Land Use Change & Encroachment Safety Management Study Report for Victorian Planning Authority

**AS 2885 Pipeline Impact Assessment of Wonthaggi North
East Precinct Structure Plan re-zoning proposal adjacent to
existing Multinet gas transmission pipeline**

Revision	Date	Description	Originator	Reviewer
A	11/8/21	Draft issued for comment	Jeff Jones	Crystal Tang (VPA)
B	27/8/21	Revised with VPA comments	Jeff Jones	Crystal Tang (VPA)
C	29/9/21	Final Report for review	Jeff Jones	Crystal Tang (VPA)
D1	15/10/21	Final Report	Jeff Jones	Crystal Tang (VPA)

FIGURE 3 – PSP Boundary and pipeline corridor area (including 143m Measurement Length)

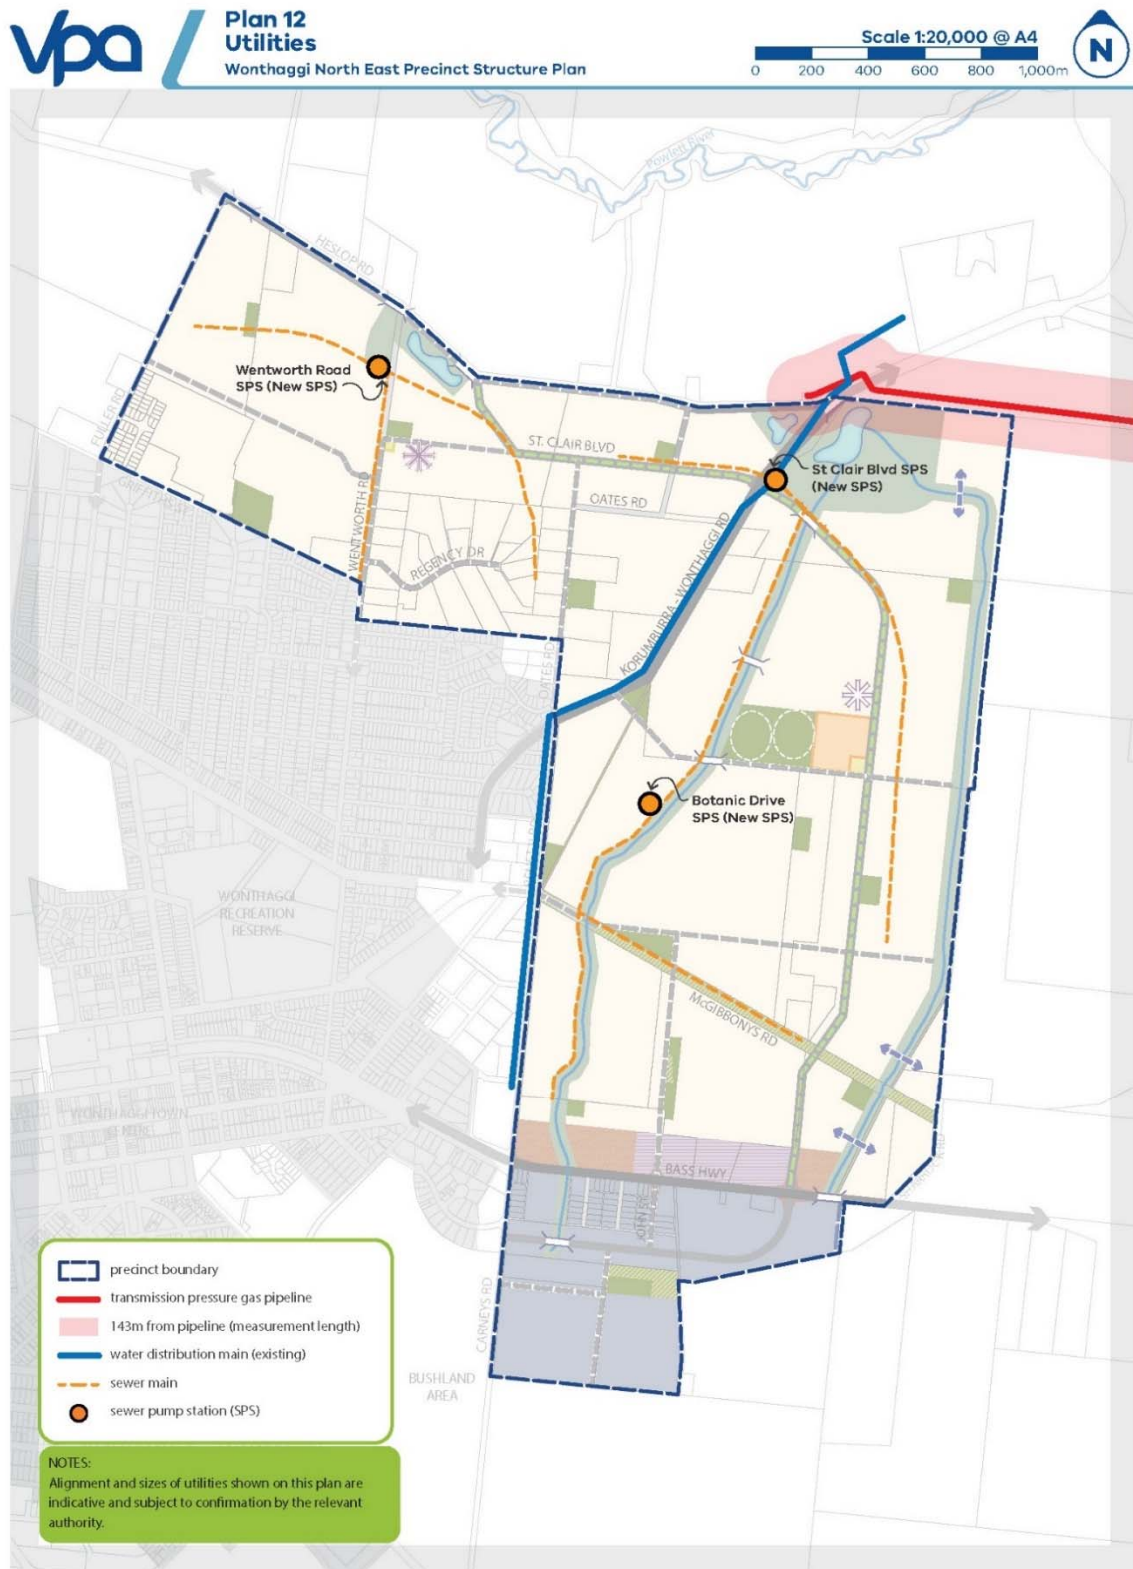
Changes to existing Location Class were assessed by assessing the proposed land use within a radius of one Measurement Length from the pipeline as per AS2885.6 Clause 2.2.

1. **Land Use Change (within pipeline/s measurement length)** – 5 items, mainly dealing with avoiding proposed T1 in the ML by re-design of the Retention Basin, thereby eliminating any required changes to MG's current R1 location classification.

1. Eliminate the introduction of population density (per As2885 T1 Location Class) or sensitive land uses within the MG pipeline 143m measurement length;
2. Refine infrastructure designs in proximity to the pipeline to the satisfaction of Multinet; and
3. Update planning documentation to the satisfaction of Multinet.

FIGURE 5 – Wonthaggi NE PSP Land Use Change

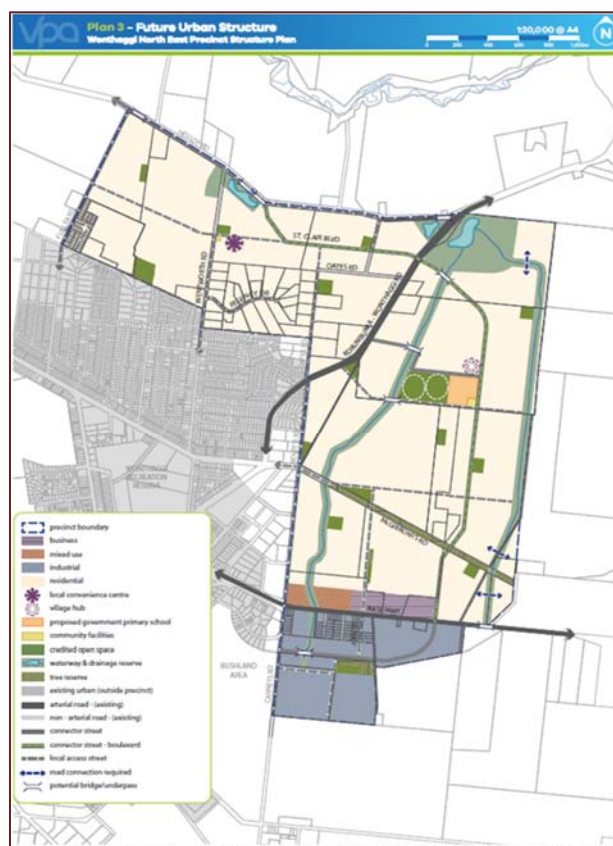
1.1	PSP – Plan 3 Future Urban Structure: “Residential”	Will result in a change of current primary location classification Rural (R1) to Town Suburban (T1) <ul style="list-style-type: none">- Residential- May include <10% (in ML) higher density / shopping	Change of land use assessment required <ul style="list-style-type: none">- Assessment to meet High Consequence Area requirements<ul style="list-style-type: none">o “No-rupture” Pipeo Maximum Energy Release (<10 GJ/S)- Depth of Cover (5.4.2)- Isolation Plan (4.8.3)- Fracture control (5.3.2)- Signage spacing (4.10.1)- Patrol frequency (Part 3)- ERP (Part 3)	No impact to current LC in the section of pipeline adjacent to the PSP. Ie no review of existing controls or ALARP study necessary.	VPA to investigate the ability to revise the allocation of the PSP area within pipeline ML currently designated as “Residential” to be “Waterway & Drainage Reserve” ie for use as part of the Retention Basin. If investigation can’t achieve no T1 in ML, will necessitate re-evaluation of T1 implications.	No

1.4	PSP – Plan 3 Future Urban Structure: “Credited Open Space”	Will result in addition of “Crowd” secondary Location Classifications/s <ul style="list-style-type: none"> Public areas Sportsfields Walking tracks in Retention Basin 	Risk assessment of threats affecting “crowd” population.	<p>Acknowledgement that the proposed public amenity (eg walkways) in the Retention Basin within the ML would be considered accepted with existing controls.</p> <p>May need further evaluation to recognise as a Crowd Secondary Class but no implications to PSP expected.</p>	<p>Ensure Council/s aware of pipeline hazard in planning community uses.</p> <p>VPA to cover in PSP planning controls.</p>	No

2.4	Future new roads - Arterial Road Connector Street	Construction of new roadways crossing easement <ul style="list-style-type: none"> - Intersection Project (IN-03) <p>Refer MARKUP_Plan 03 Transport Projects.</p>	Need to assess threat of accidental impact with pipeline. <ul style="list-style-type: none"> - Damage to coating - Hole/Rupture of pipeline and ignited gas release - Vibration effects coating <p>May need verification gig / coating assessment.</p> <p>Crossing designs required to meet AS2885 stress loading requirements.</p> <p>May require encasing pipeline / structural (concrete slab) protection.</p>	The intersection design & construction plan will need to be approved by Licensee, including engineering reviews to confirm stress affects and if any protection is required. <p>May also require an inspection dig of coating condition. Ie if future access is constrained or any known defects.</p>	Include Licensee requirements in PSP schedule as a planning condition to trigger future MG involvement (referral) and design approval.	No

3. VPA to update the appropriate PSP Future Urban Structure Plan with the confirmed pipeline location & depiction of the Measurement Length
4. EnGenY/VPA to revisit drainage strategy and ability to "re-design" the drainage basin area/layout to eliminate T1 in ML in PSP
